REQUEST

Proposed Zoning: UR-2(CD) (urban residential, conditional)

The petition proposes to allow an infill residential development with 26 single family attached (townhome) units on vacant land north of the intersection of The Plaza and Milton Road.

STAFF RECOMMENDATION

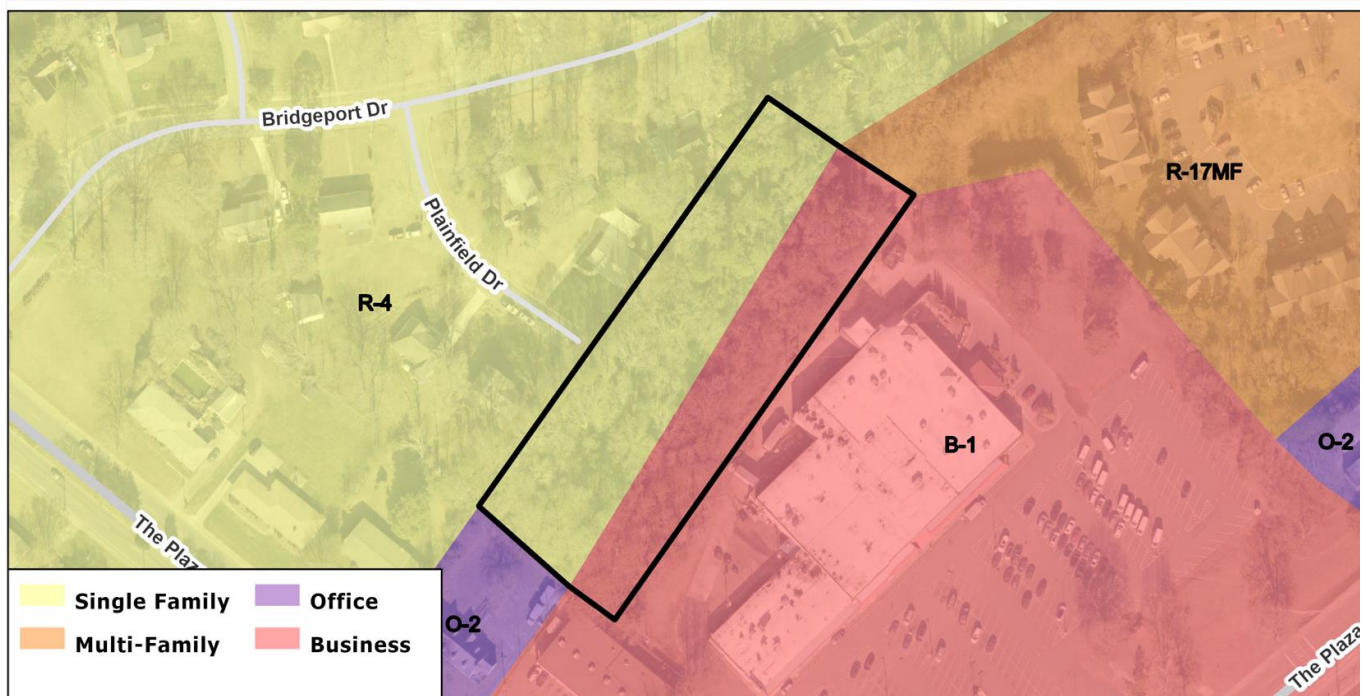
2. Ensure that tree save meets proper standards. Protected tree save should be roughly 30 feet wide. Any tree save not protected to meet the minimum requirements will need to be replanted at 150%
